TO: Mercedes-Benz Dealer Principals, General Managers, Sales Managers, Service Managers, Parts Managers	FROM: Gregory Gunther, Department Manager, Vehicle Compliance and Analysis, Engineering Services
RE: Recall Campaign - Launch Notification Rear SAM Cover Retrofit MY22 C-Class (206 platform)	DATE: November 19, 2022

Recall Campaign Launch Notification			November 19, 2022
Campaign No. :	NHTSA ID	Campaign Desc. :	Rear SAM Cover Retrofit
2022090011	22V678	22P6391006	
<p>This is to notify you of the Recall Campaign launch to retrofit a cover for the Rear SAM on 6,752 Model Year (“MY”) 2022 C-Class (206 platform) vehicles. The recall campaign will be visible on the www.safercar.gov website and may generate questions from customers. Affected VINs will be flagged in VMI as “OPEN” on November 19, 2022.</p>			
Background			
Issue	<p>Mercedes-Benz AG (“MBAG”), the manufacturer of Mercedes-Benz vehicles, has determined that in the event of water ingress into a particular section of the trunk in certain Model Year (“MY”) 2022 C-Class Sedan (206 platform) vehicles, moisture might enter the rear signal acquisition and actuation module (SAM). In this case, a short circuit might occur in the rea

Figure 1

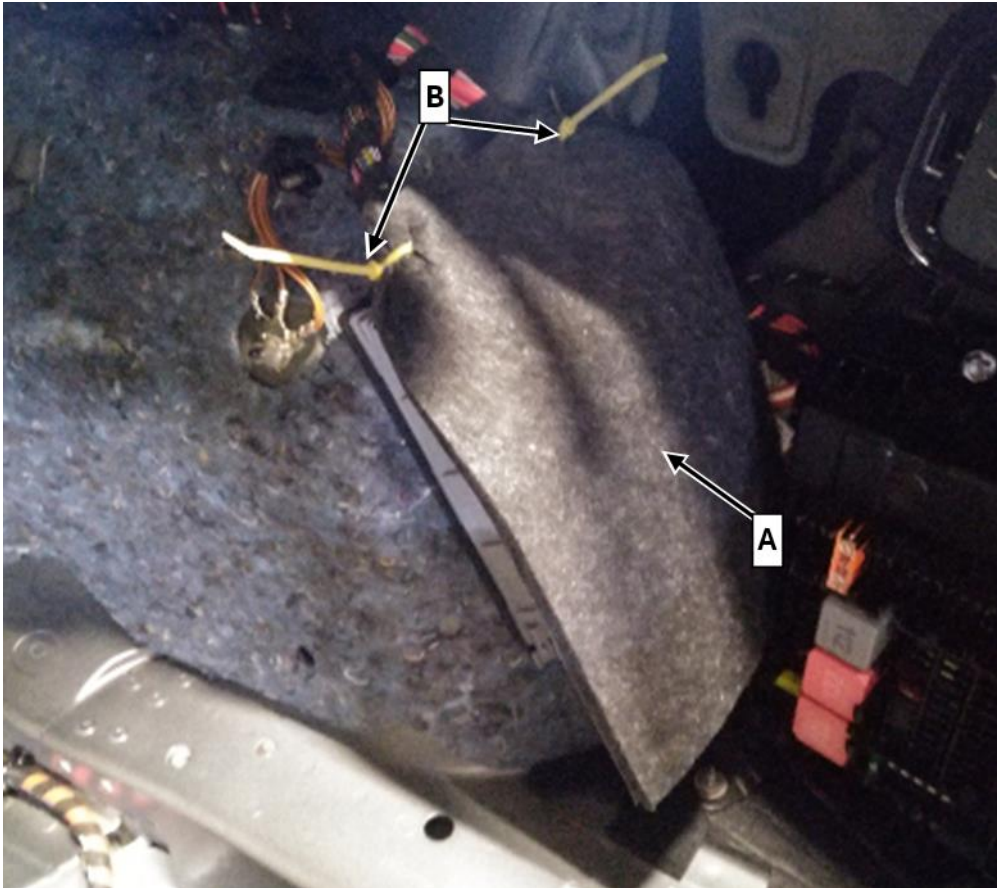
1. Loosen rear right trunk lining and fold inward.
2. Retrofit felt (A, figure 1)
 - i** To do this, dispose of the 2 clips from the new felt and attach two cable ties (B, figure 1) to both electric lines.
 - i** The grey smooth side has to face against the control unit.

3. Shorten protrusion of the cable tie.
 4. Assemble in reverse order.
-
